SUBSURFACE WASTEWATER DISPOSAL SYSTEM APPLICATION

Subject: New System Variance approval, Cobb property, Easterly lot,
Prescott Rd., Augusta

12-17-90 This is a revision to permit number #1850 issued 5-2-90 to Ken Cobb. [Signature]

SUBJECT: New System Variance, Adams property, Prescott
Road, Augusta

SUBSURFACE WASTEWATER DISPOSAL PLAN

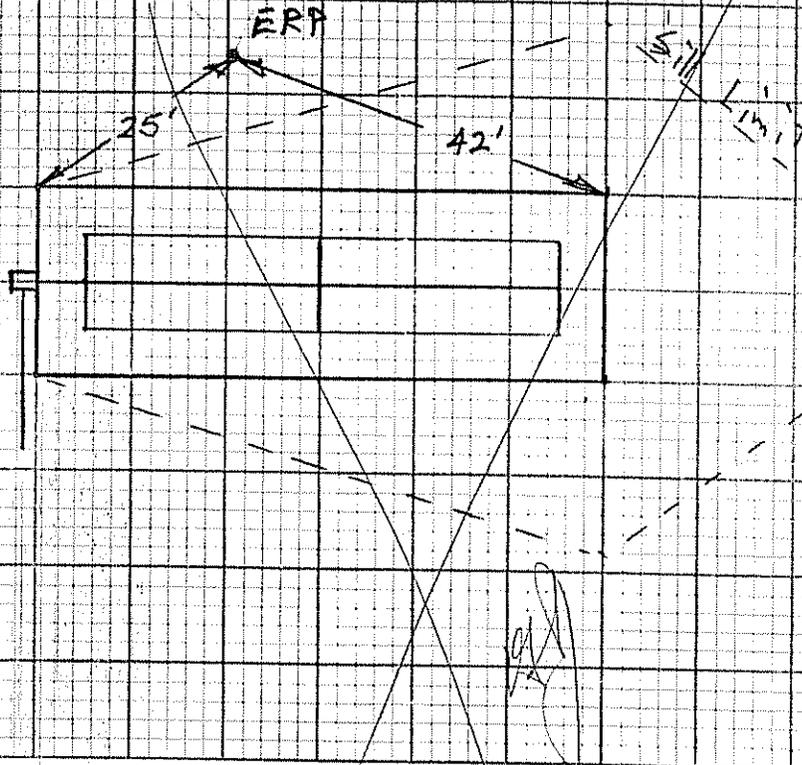
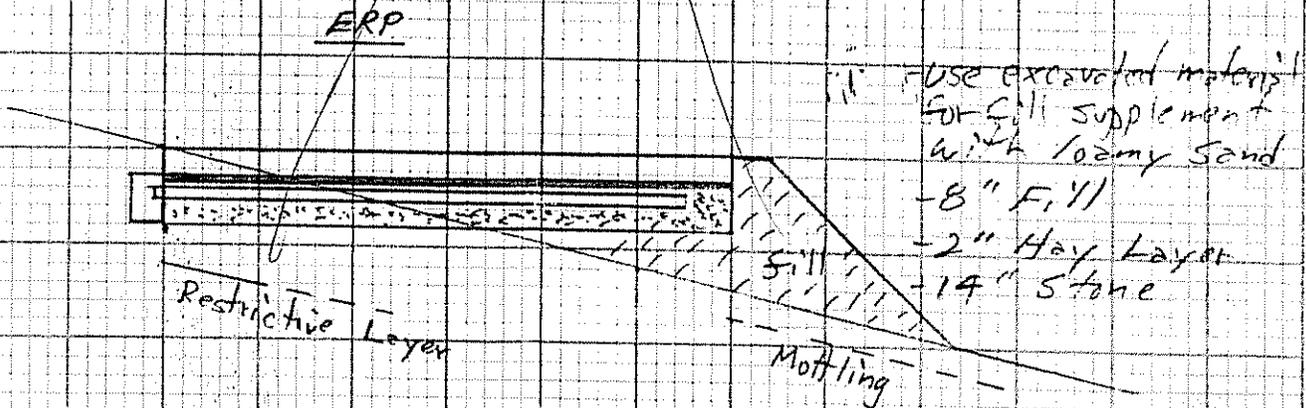
10-18-90 - Visit site foundation to close to this septic. new design will have to be drawn up. new permit fee now \$1400.00

SUBSURFACE WASTEWATER DISPOSAL PLAN

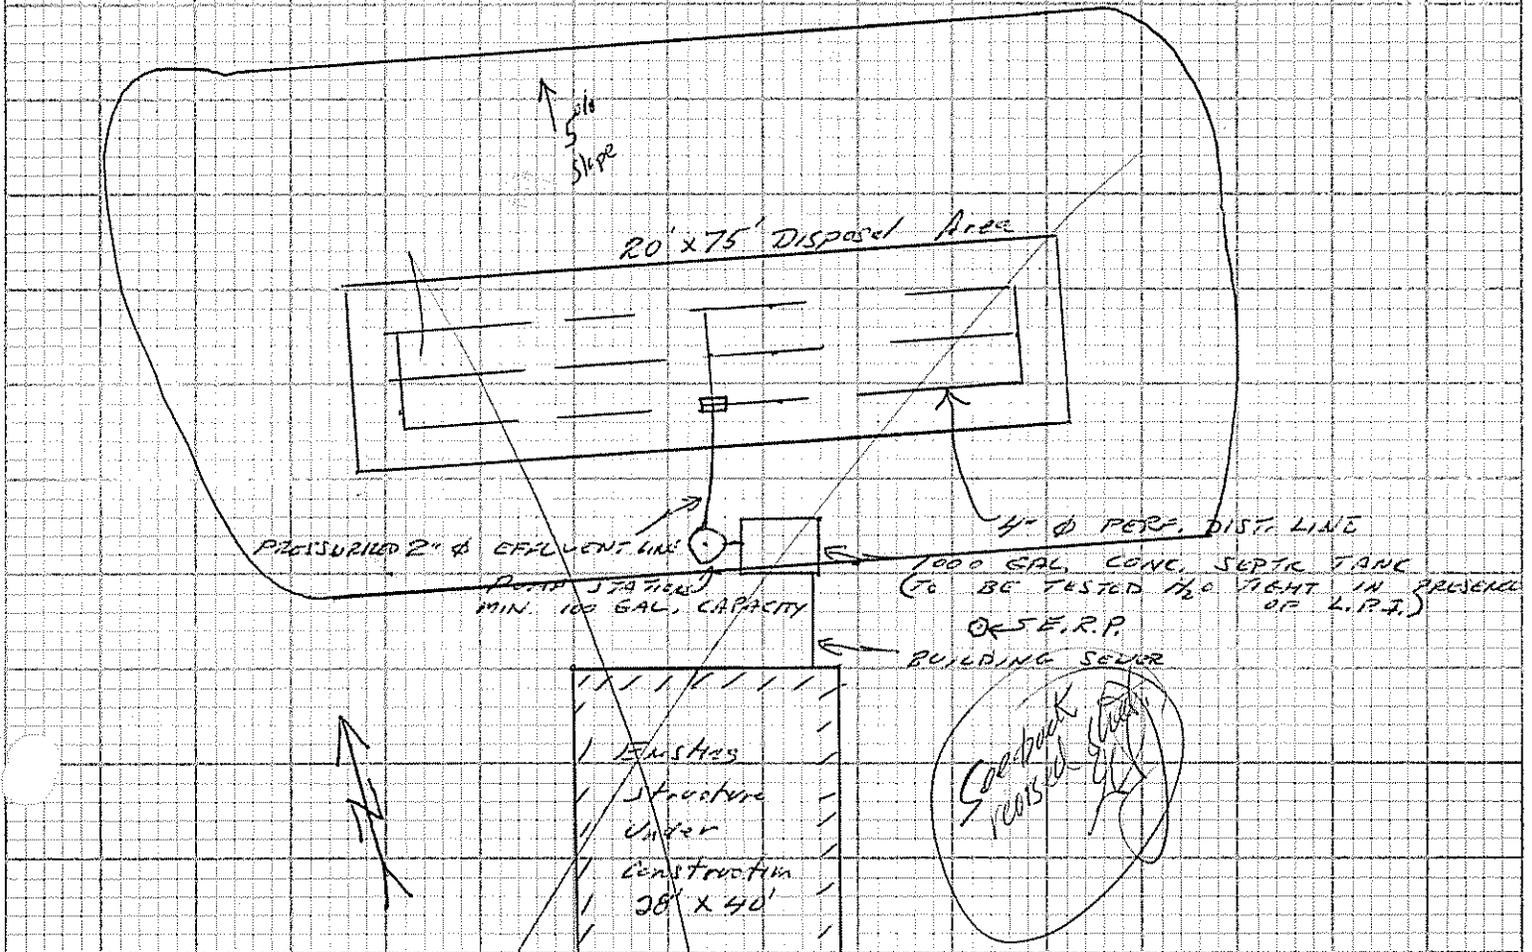
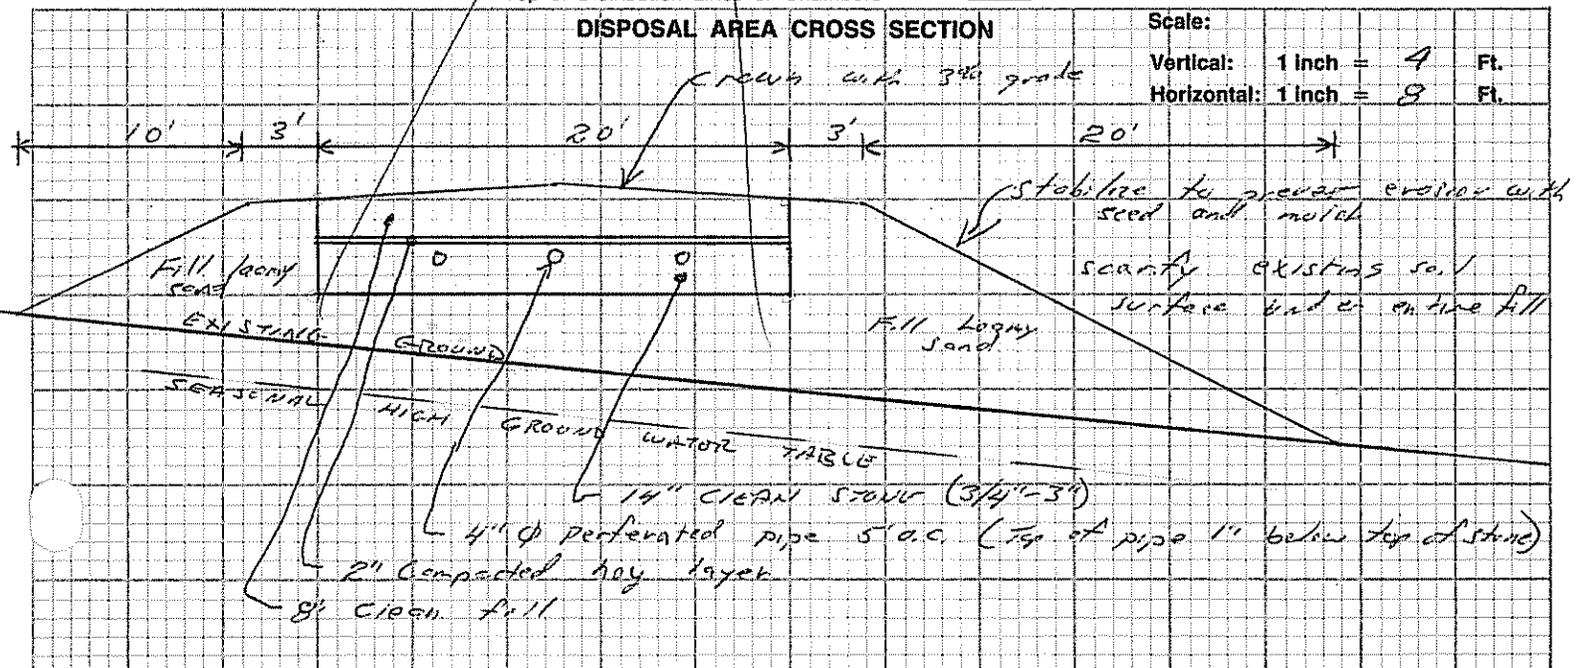
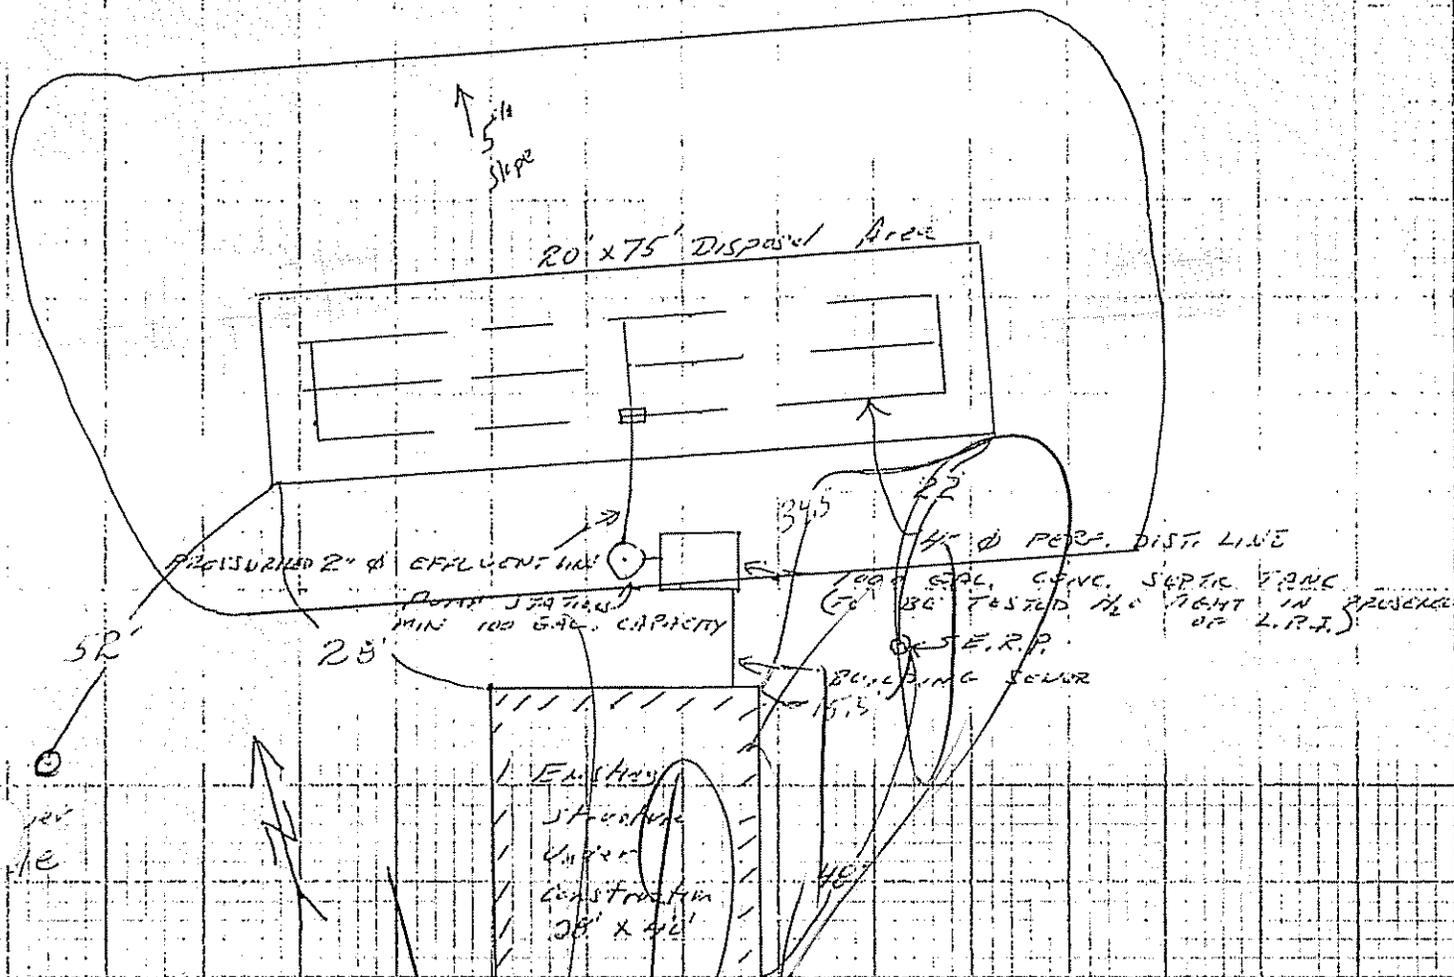
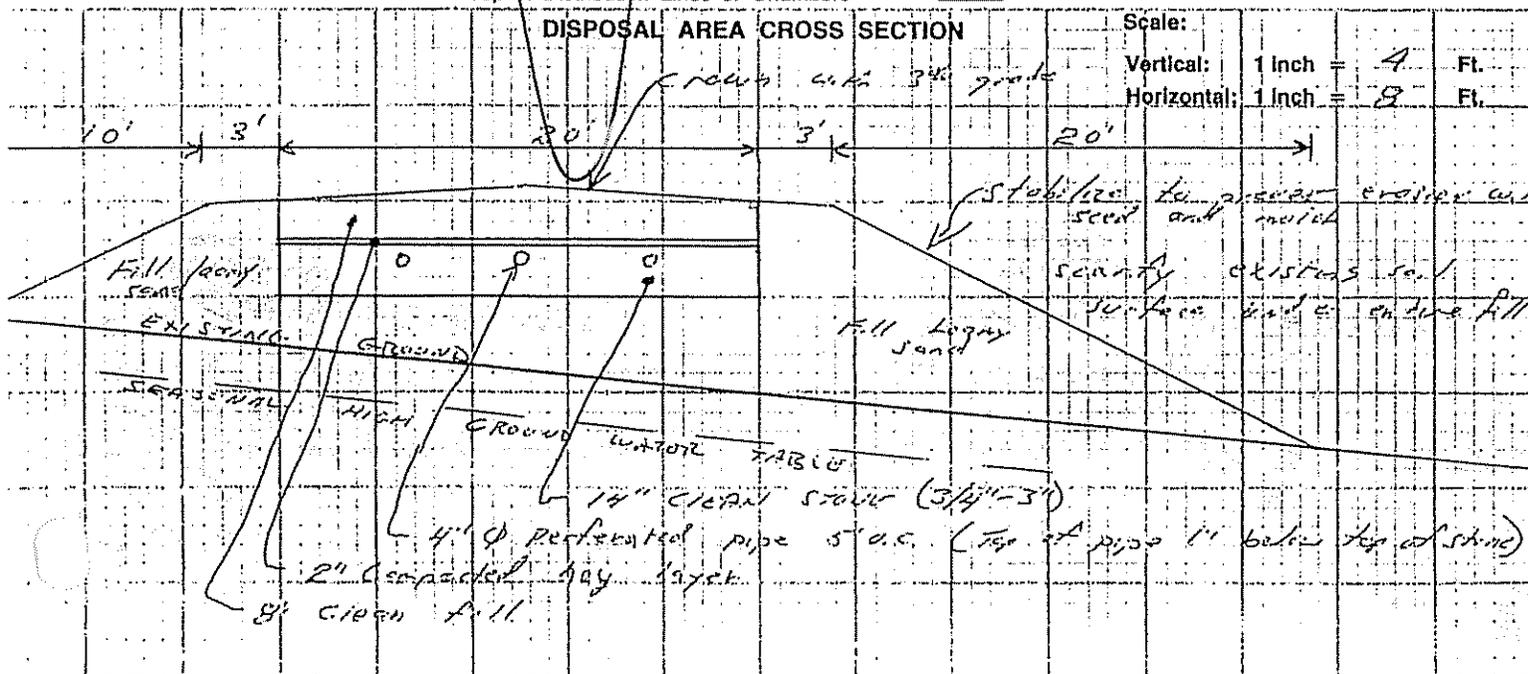
According to 10-144A CMR 241.6.A.4, the corners of the disposal field shall be referenced from established control points in the field.

In this way the contractor can locate where the system shall be located even if the markers in the field were to be moved or destroyed.

Once we receive these revisions, we will proceed with the application as soon as possible.
